Newmar Corporation

Technical Service Bulletin							
Date Issued		Model Year(s) Affected		Model(s) Affected		TSB #	
10/20/2006		2004 - 2005		Spartan Chassis		278	
Brand						Type	
All	<input type="checkbox"/>	American Star	<input type="checkbox"/>	Mountain Aire	<input checked="" type="checkbox"/>	All	<input type="checkbox"/>
		Dutch Star	<input checked="" type="checkbox"/>	Kountry Aire	<input type="checkbox"/>	T T	<input type="checkbox"/>
		Kountry Star	<input type="checkbox"/>	Essex	<input type="checkbox"/>	F W	<input type="checkbox"/>
Scottsdale	<input type="checkbox"/>	Northern Star	<input type="checkbox"/>	London Aire	<input type="checkbox"/>	D P	<input checked="" type="checkbox"/>
<div style="display: flex; justify-content: space-between;"> <div> <input type="checkbox"/> Air Conditioning & Heating <input type="checkbox"/> Appliances & Accessories <input type="checkbox"/> Cabinets & Furniture <input checked="" type="checkbox"/> Chassis Components <input type="checkbox"/> Construction Components </div> <div> <input type="checkbox"/> Electrical Components <input type="checkbox"/> Exterior Components <input type="checkbox"/> Interior Components <input type="checkbox"/> Plumbing &

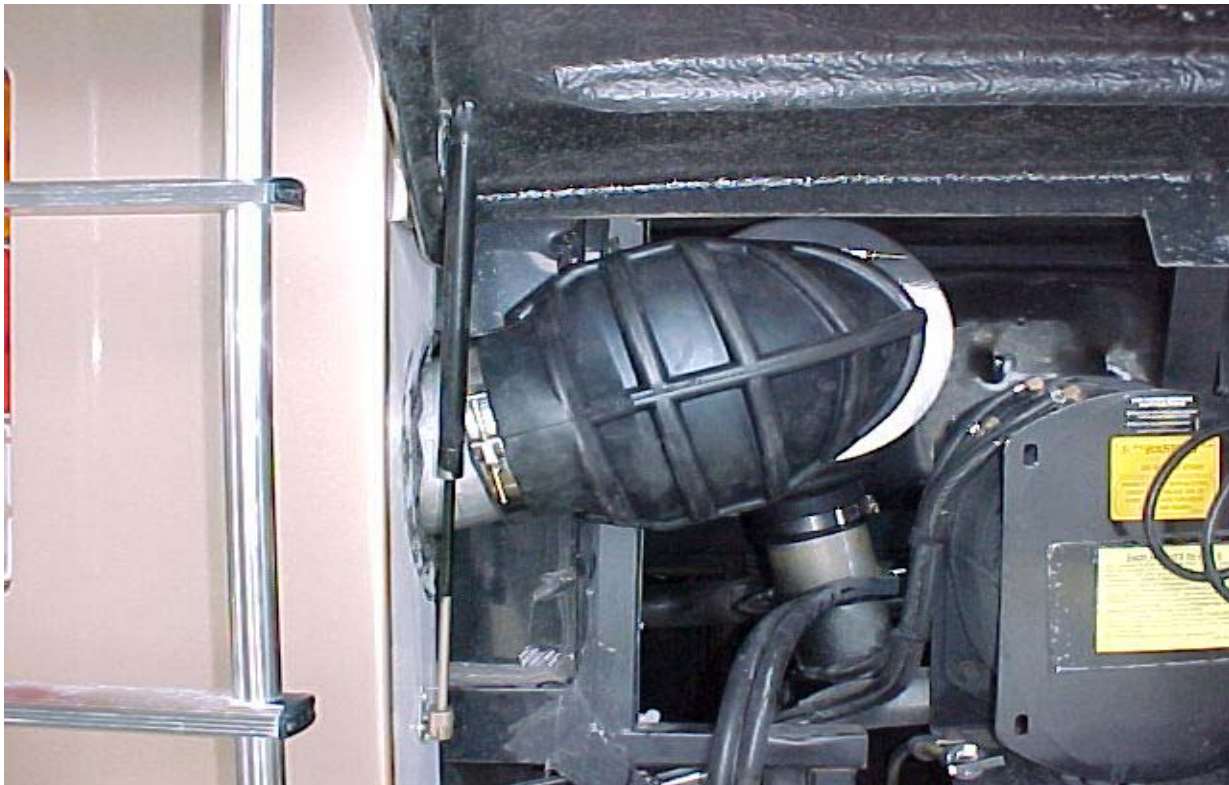
The turbo speed sensor connector located at the transmission is not used and is uncapped. Wires are WT149 (orange) and WT140 (blue) in wire harness p/n 2417-GG5A-002. Corrosion in this connector may trigger a false check trans light and may or may not store a 22-15 TCU code.

- Locate the connector with WT149 orange and WT140 blue wires at the turbine speed sensor connector at the transmission.
- Cut the connector off of wires WT149 (orange) and WT140 (blue).
- Use heat shrink tube to seal each wire and secure the wires.
